LOCAL HISTORIC DISTRICT: Wilmore

PROPERTY ADDRESS: 301 West Park Avenue

SUMMARY OF REQUEST: Window changes

SHEET
A-1

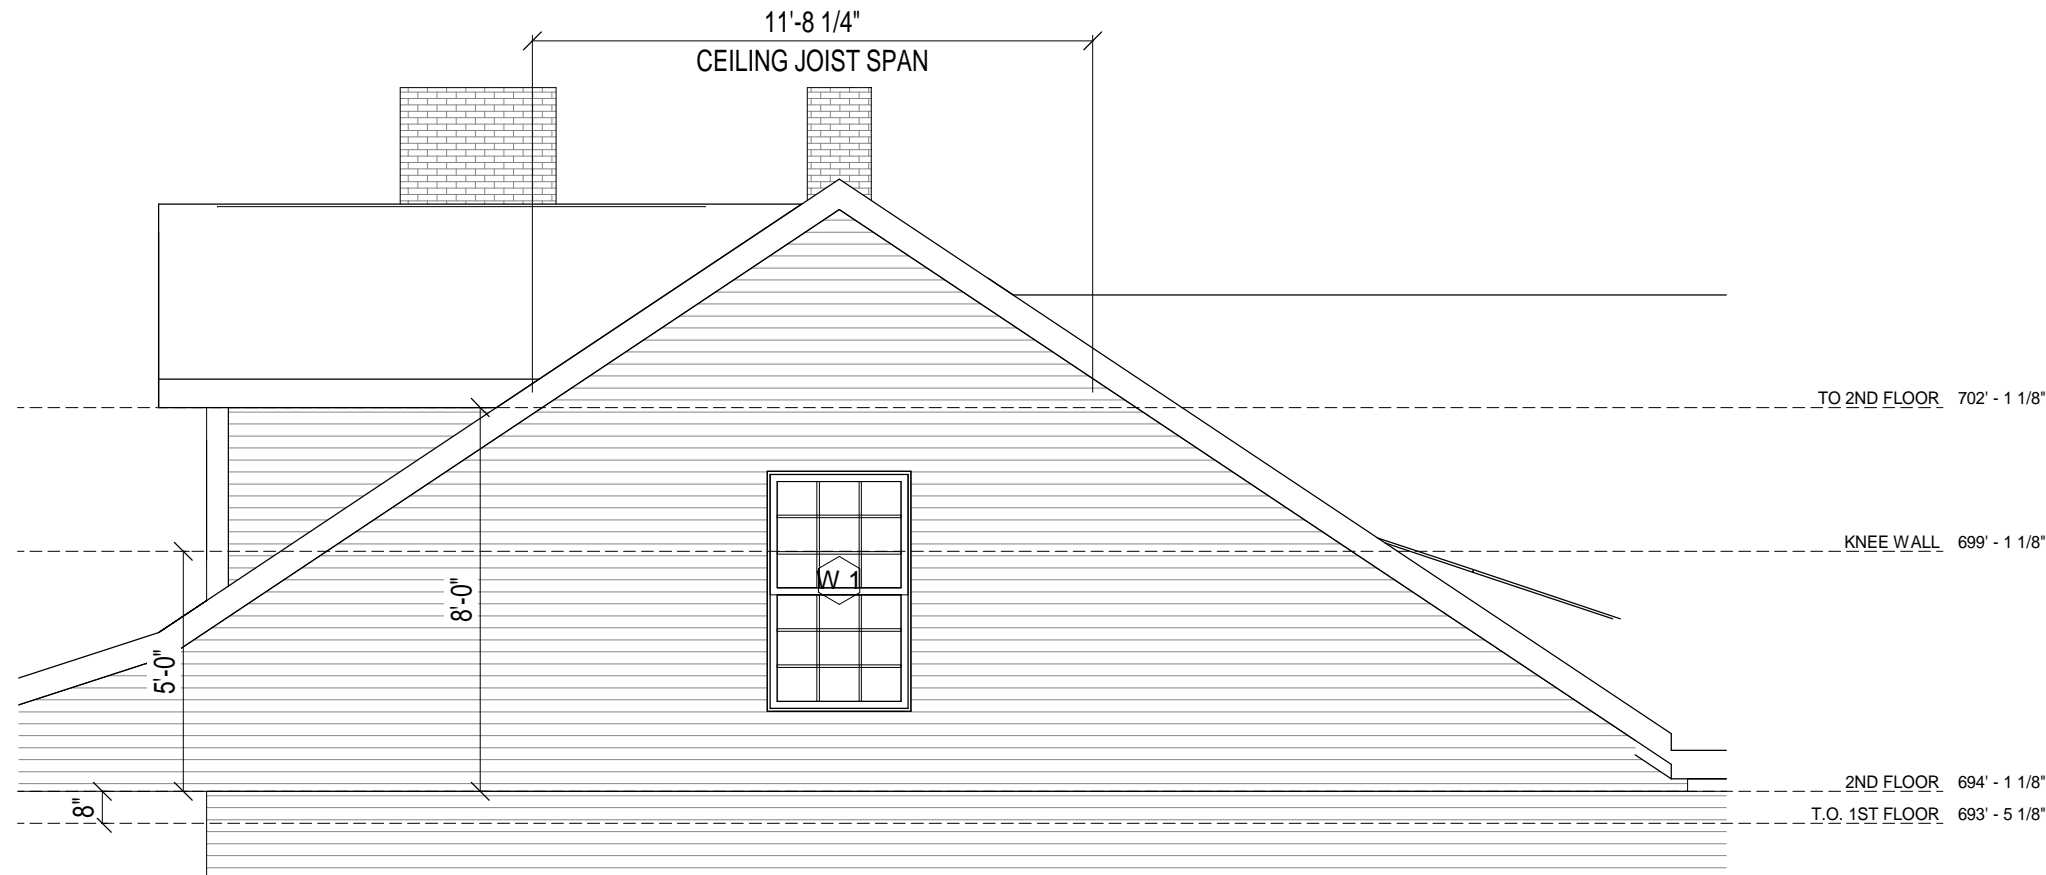
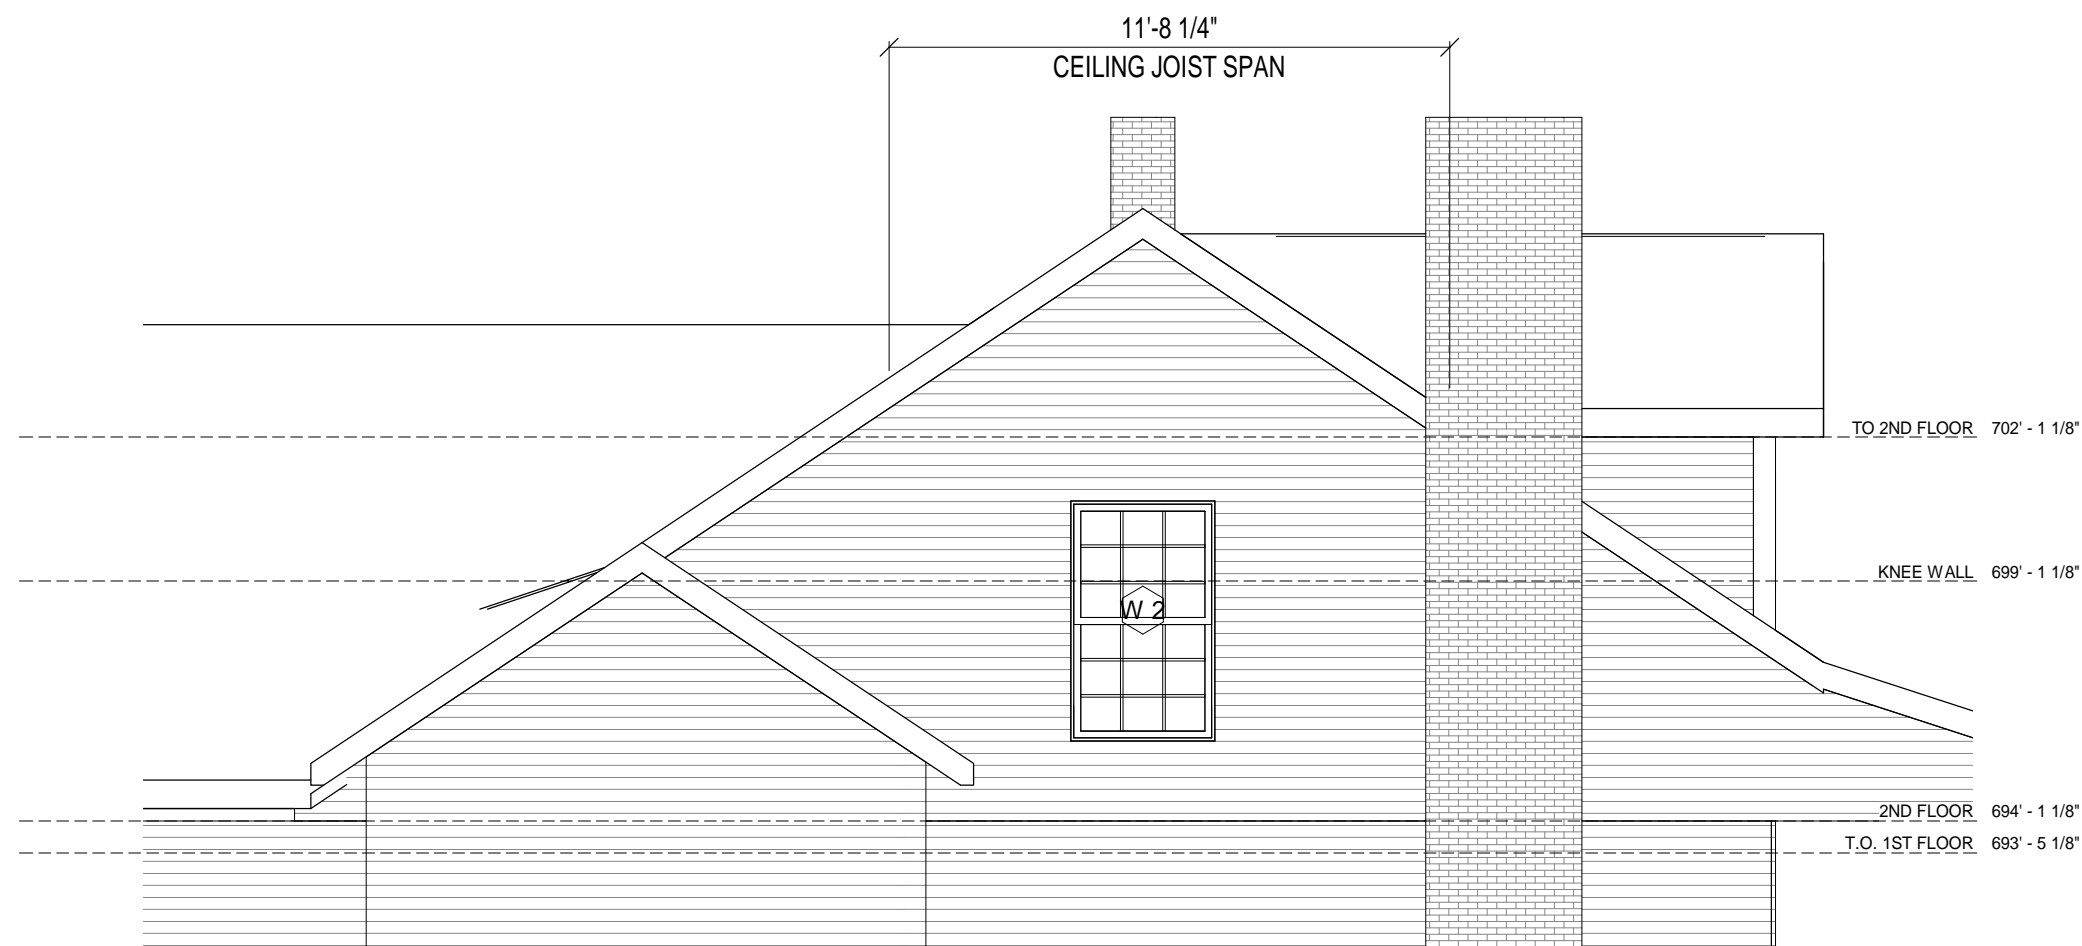
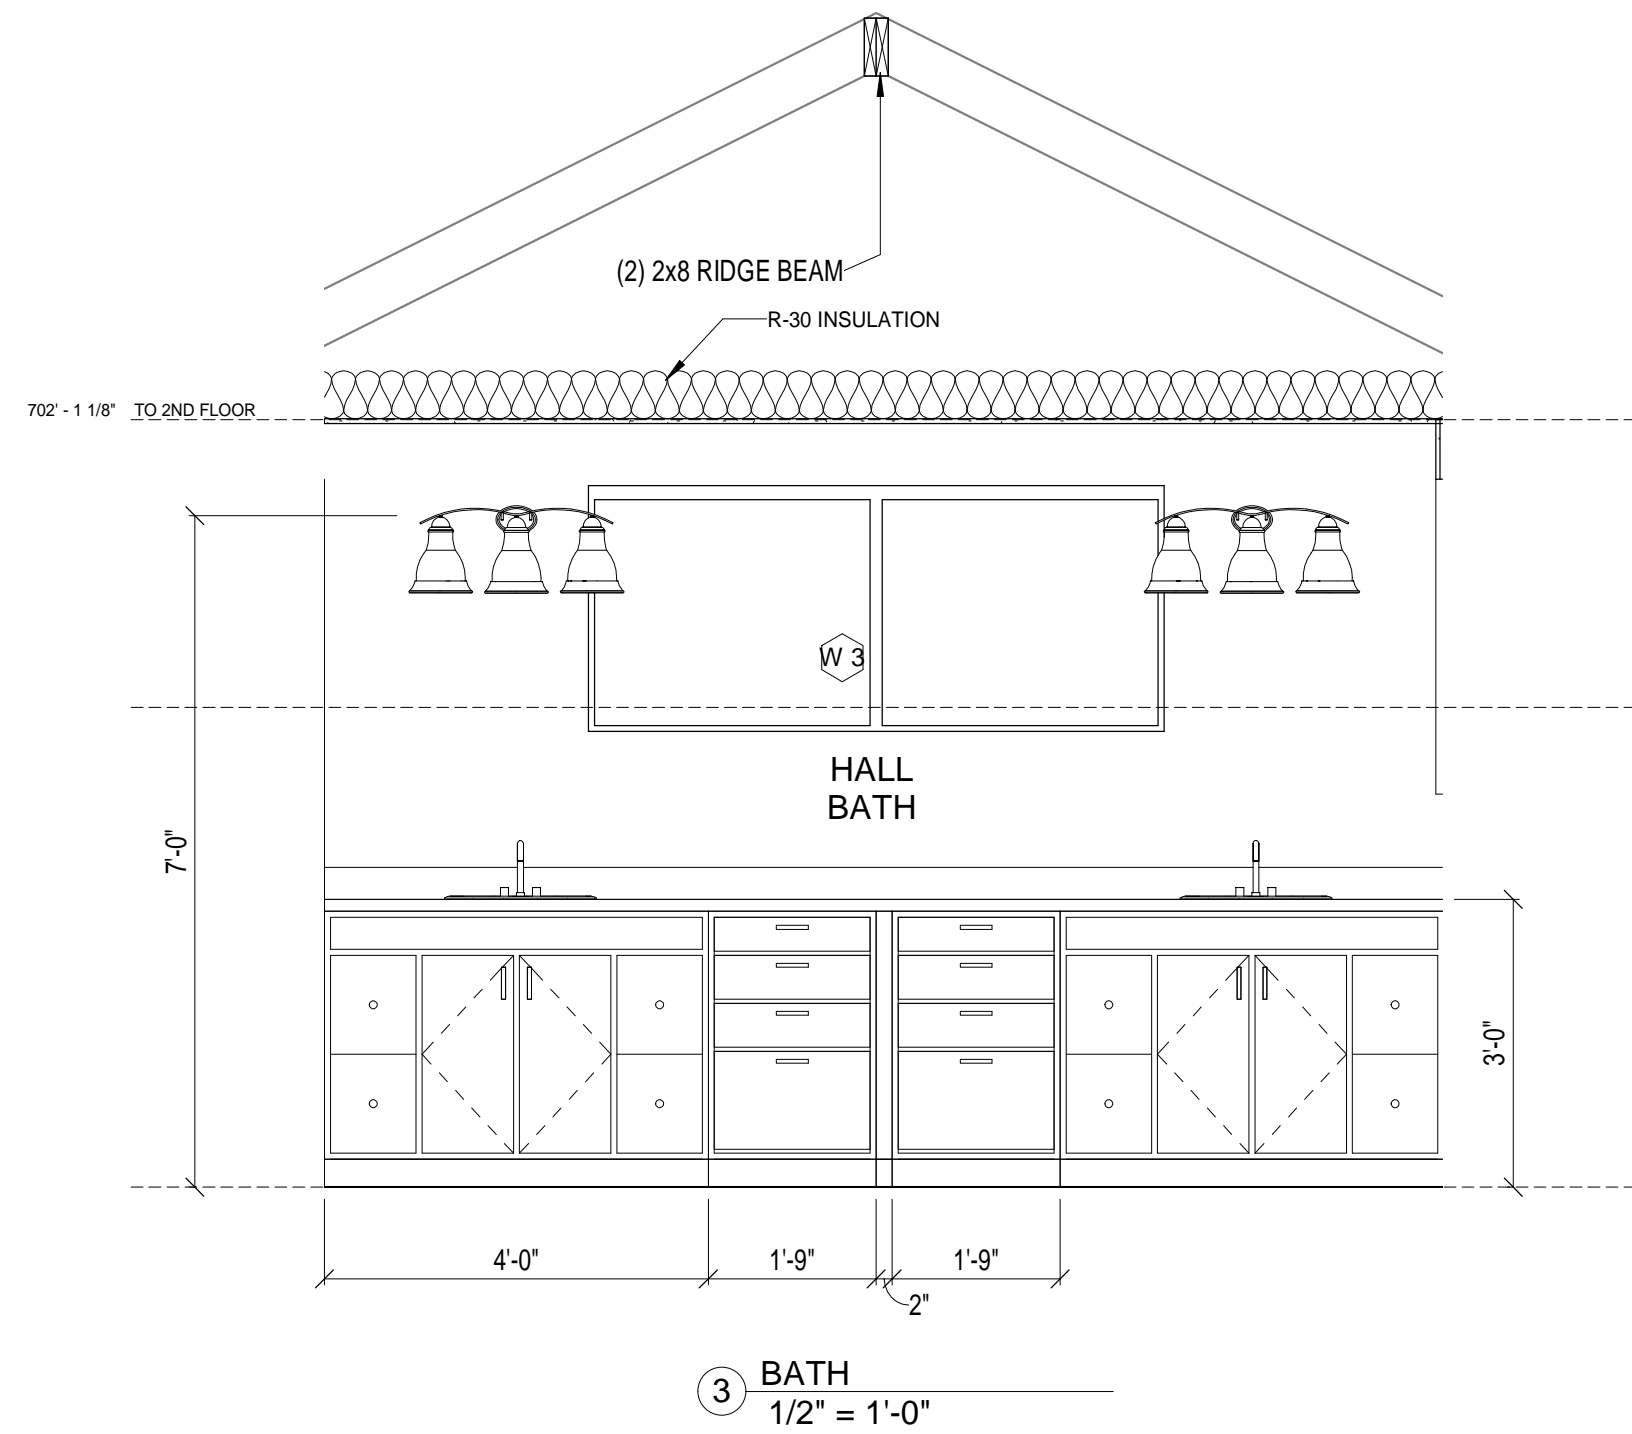
Staff has the following concerns with the proposal:

1. A single window, rather than a paired window, is better suited for the space available in the gable ends.
2. Accurate drawings for the new window openings including trim dimensions, divided light pattern, and window size/location.
3. The proposal is not incongruous with the District and meets the applicable guidelines for Building Materials-Wood, 5.2, and Additions 7.2, #3, and #6, and is consistent with applicable Secretary of the Interior's Standards, # 9 and 10.
4. Minor revisions may be reviewed by staff, including trim dimensions, and window design, and size.
